DOCUMENT 00912

ADDENDUM NUMBER 2

Issued: September 16, 2010

**1315 Airport Boulevard Tenant Improvements
(Geothermal Heat Pump Retrofit)**

CONTRACT NUMBER: 10-83-7 #1
DRAWING NUMBER: **MO.00**

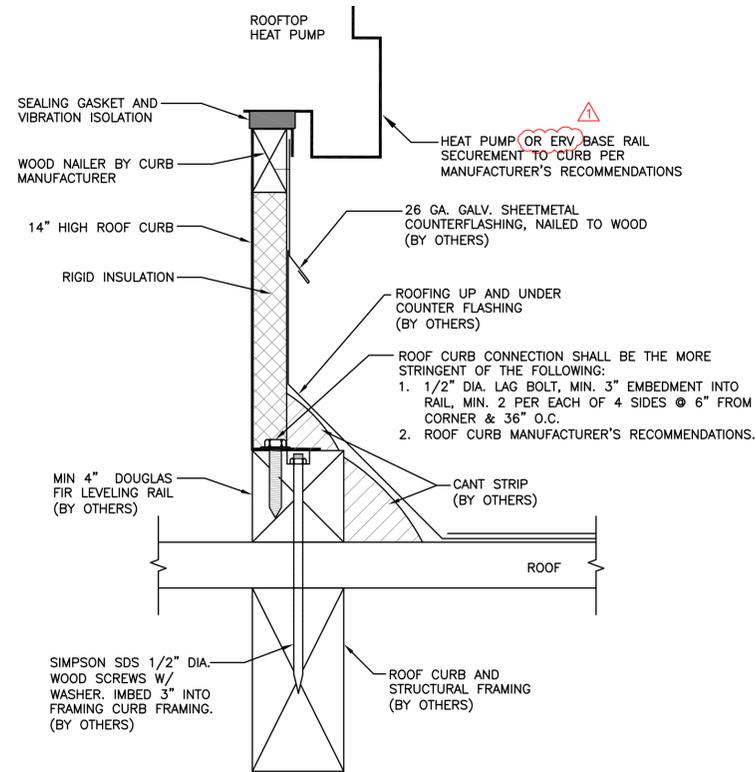
NO.	DATE	REVISION	BY
	9/14/2010	LAB EXHAUST CHANGES - ADDENDUM NO. 2	JP

HEAT PUMP & ERV ROOF MOUNT DETAIL
SCALE: NONE

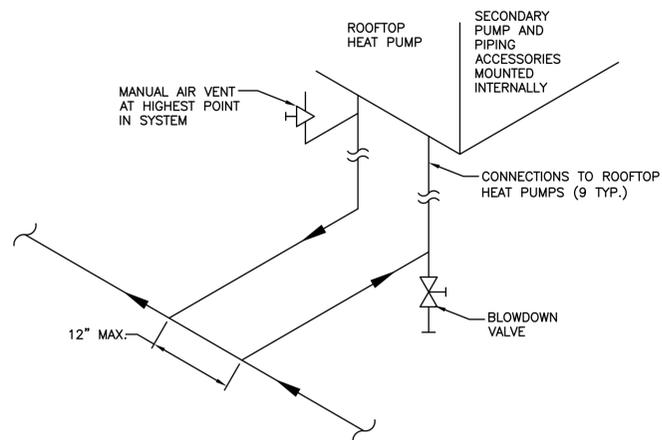
- a. C. Roof curbs for Energy Recovery Ventilators shall be supplied by the unit manufacturer for field assembly.
- [renumber remaining paragraphs accordingly]
